Commonwealth Edison
1400 Opus Place
Downers Grove, Illinois 60515

March 12, 1990

Subject: Byron Station Units 1 and 2
Braidwood Station Units 1 and 2
Supplement to Application for Amendment to
Facility Operating Licenses
NPF-37, NPF-66, NPF-72 and NPF-77,
Appendix A, Technical Specifications
NRC Docket No.s 50-454, 50-455,
50-456 and 50-457

Figure 1

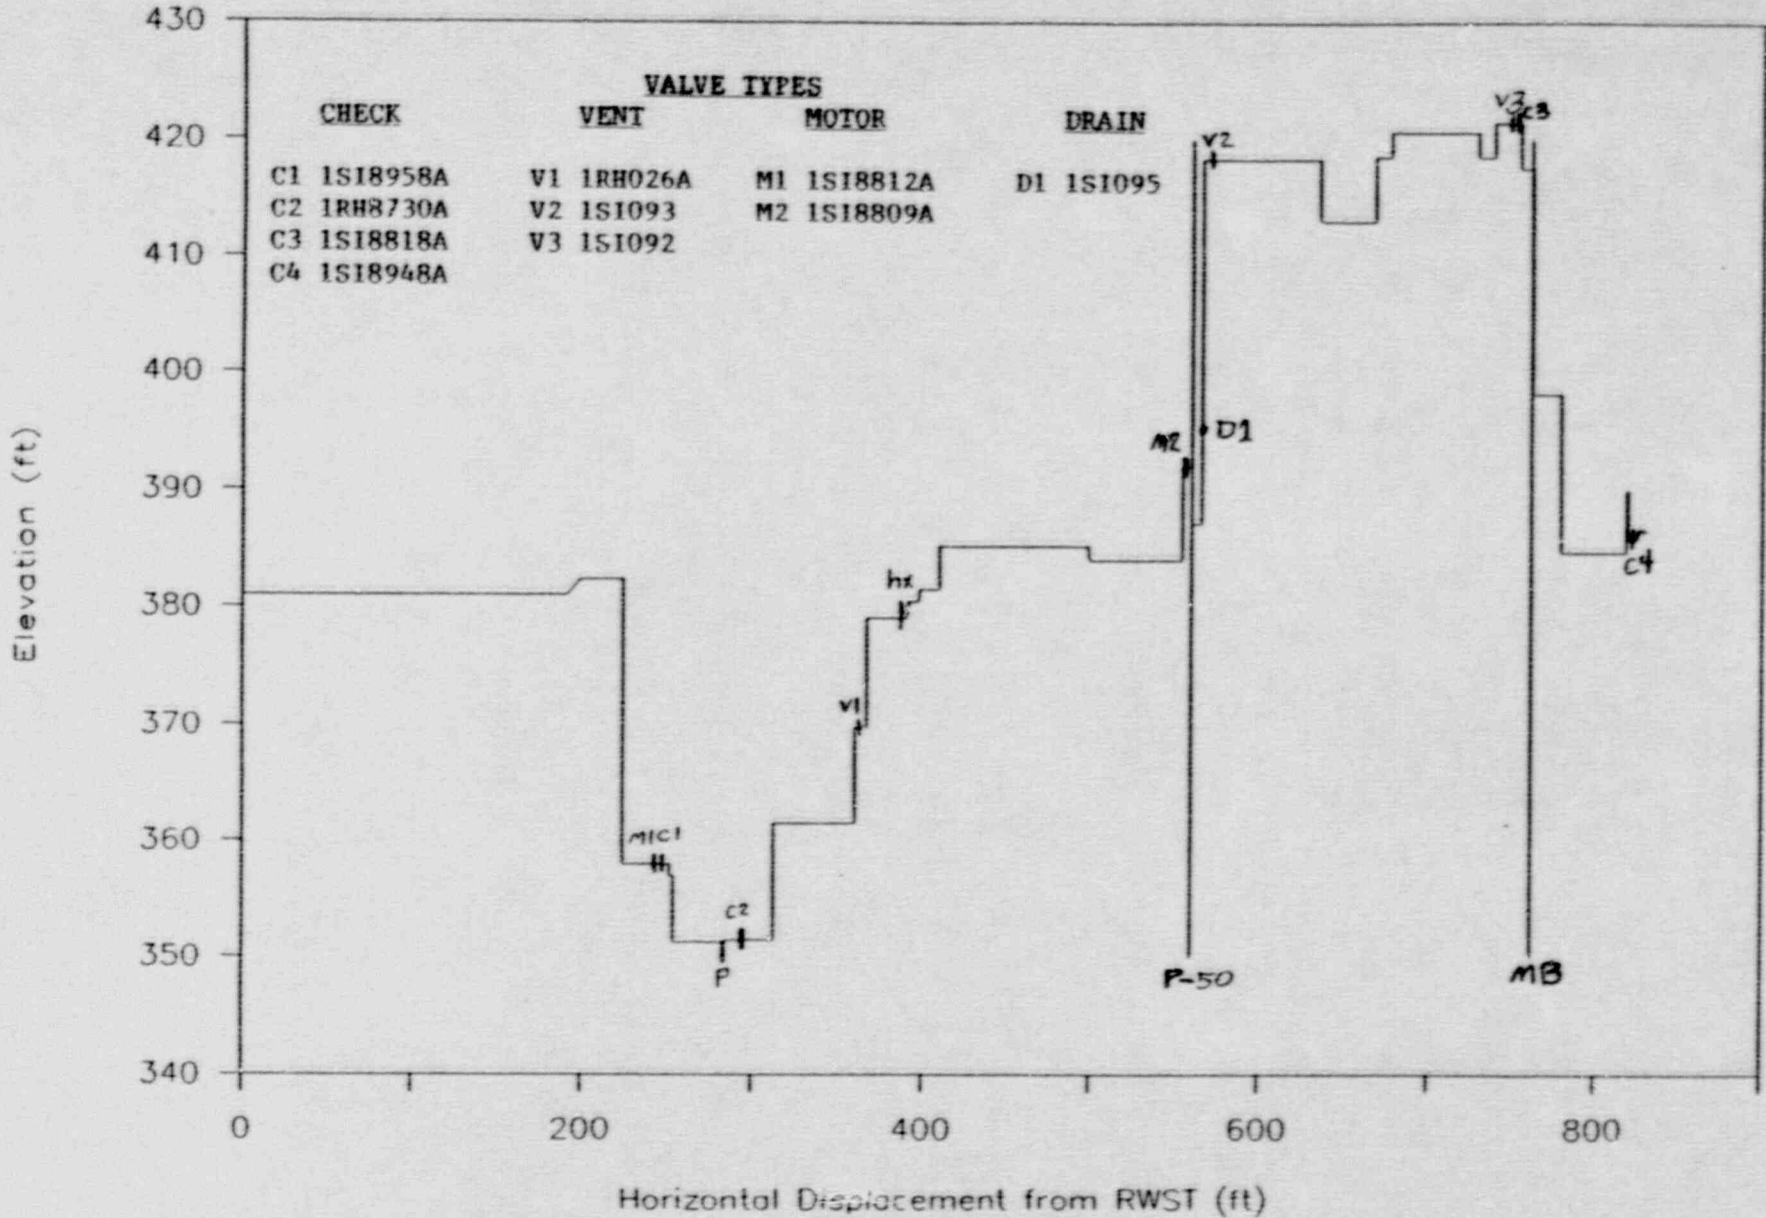
- 1) Describe Byron's and Braidwood's ECCS venting experience and describe the results of venting surveillances seen in all applicable modes of operation.
- 2) Provide a summary of Unit 1 and Unit 2 differences.

Item A.1: Provide feedback on industry experience regarding venting. Include IN 88-23, Supplement 1 and why it is not applicable.

Response: Edison's response to the Farley event is shown in Table 1. This table summarizes calculations done to determine if hydrogen could come out of solution in the VCT to CCP suction line by calculating the delta-pressures between various points in the piping line and the VCT outlet. If this delta-pressure is positive it can be concluded that the hydrogen introduced in the VCT will remain in solution at that point in the system. Additionally, high points were identified and all connections were evaluated for collection of hydrogen. It was determined that the Byron and Braidwood Units are not susceptible to the type of hydrogen accumulation identified at Farley.

Edison's response to the South Texas event is shown in Table 2. This table summarizes calculations performed to determine if pressures less than atmospheric could exist in the CCP suction line when suction is transferred from the VCT to the RWST by calculating the delta pressures between various points in the piping line and the RWST outlet (assuming the RWST is empty). Since this delta-pressure is positive it can be concluded that the South Texas event is not credible at the Byron and Braidwood Stations.

A compilation of the elevation diagram of the RWST and VCT to CCP suction is provided in Figure 1. It should be noted that both the Farley and South Texas events were caused by extreme high points in the ECCS pump suction line relative to either the VCT or RWST. Byron and Braidwood Stations do not have high points in the ECCS pump suction lines of the magnitude found at the Farley and South Texas plants.

Figure 2

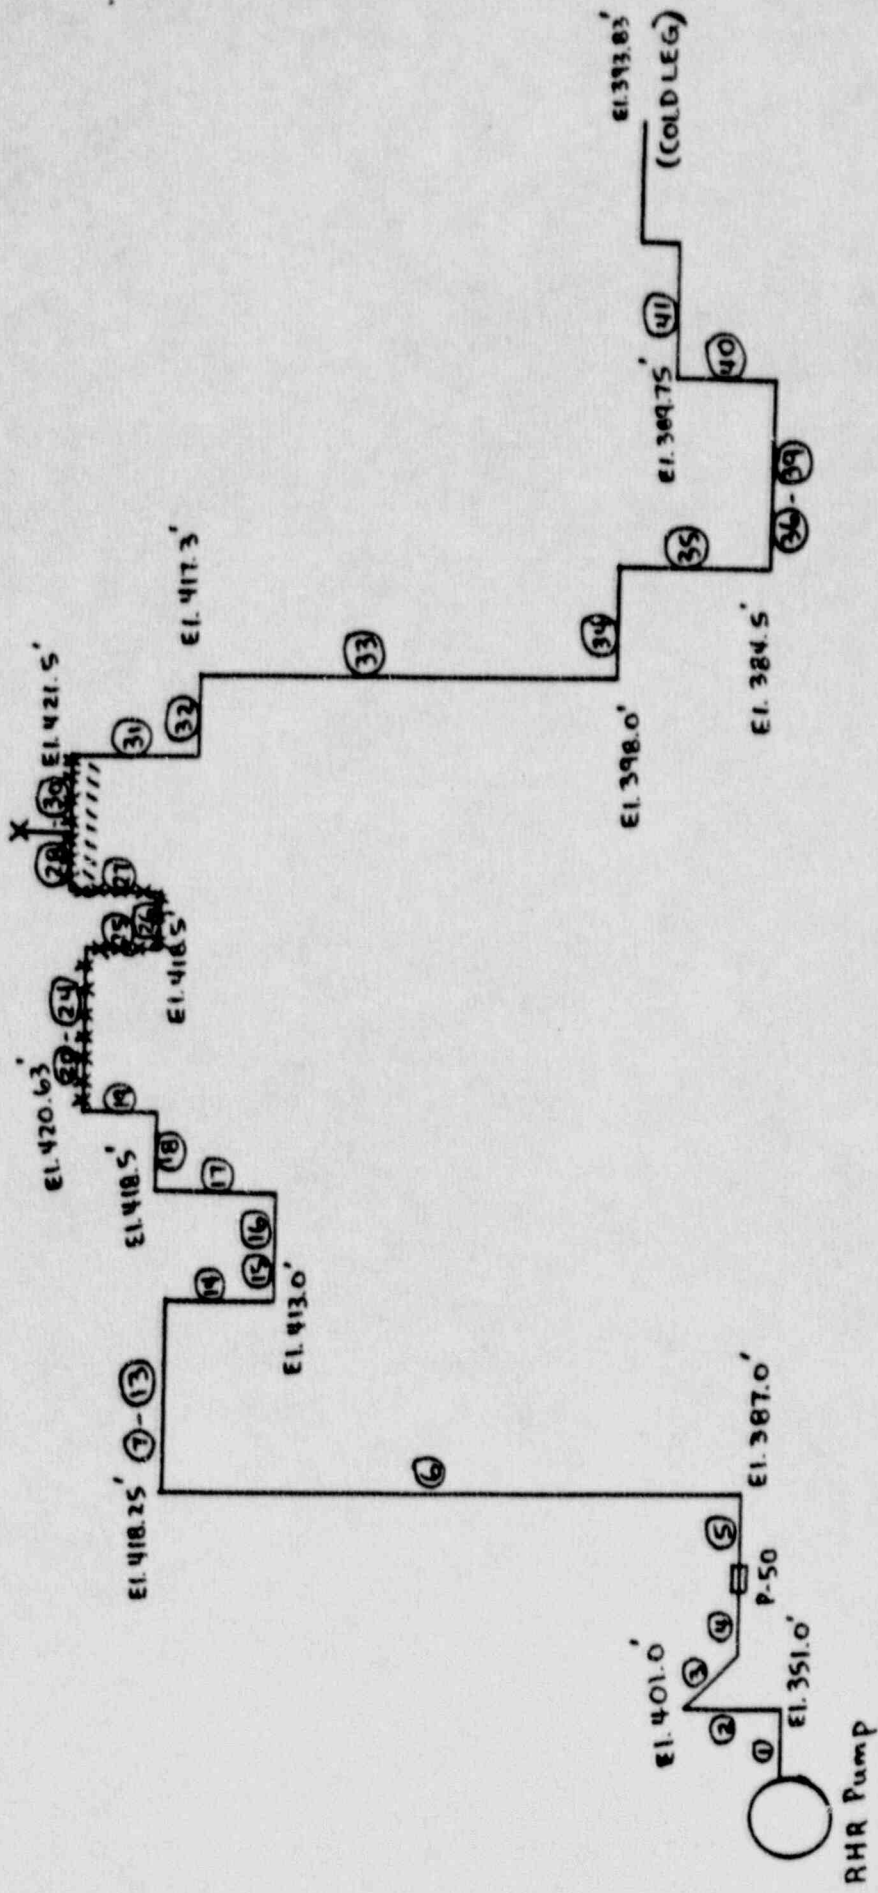
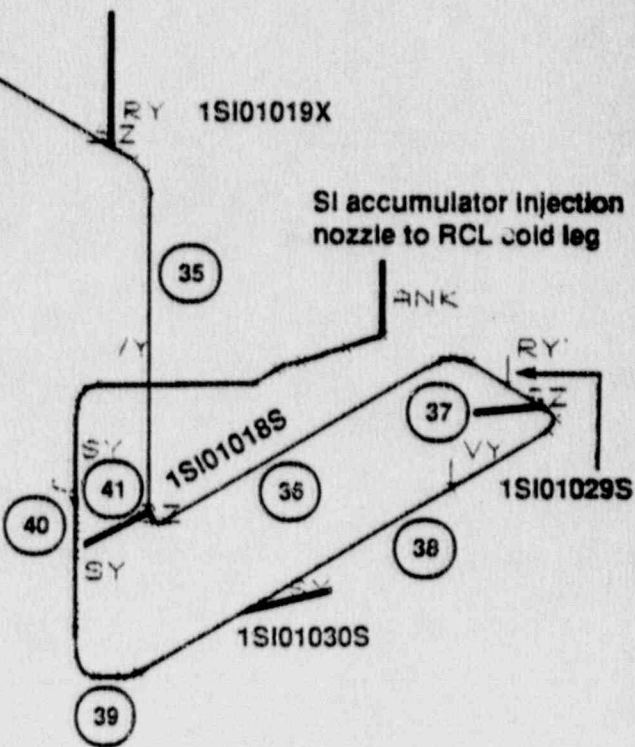
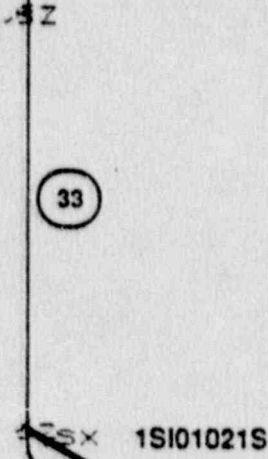
Item B.4: Provide a "waterhammer" analysis based on postulated air sources. Also document the worst case scenario that represents a line that is completely filled with air on the discharge side of the RHR pump.

As a worse case estimate, the RHR ECCS supply line to loop 1, inside the containment, was studied. The line has the largest diameter piping, a long pipe length, and high elevation segments. Figure 1 is a profile of the piping. Figure 2 shows the location of the assumed air pocket and the number of the pipe segments. Table 1 tabulates the forces for a large bubble case.
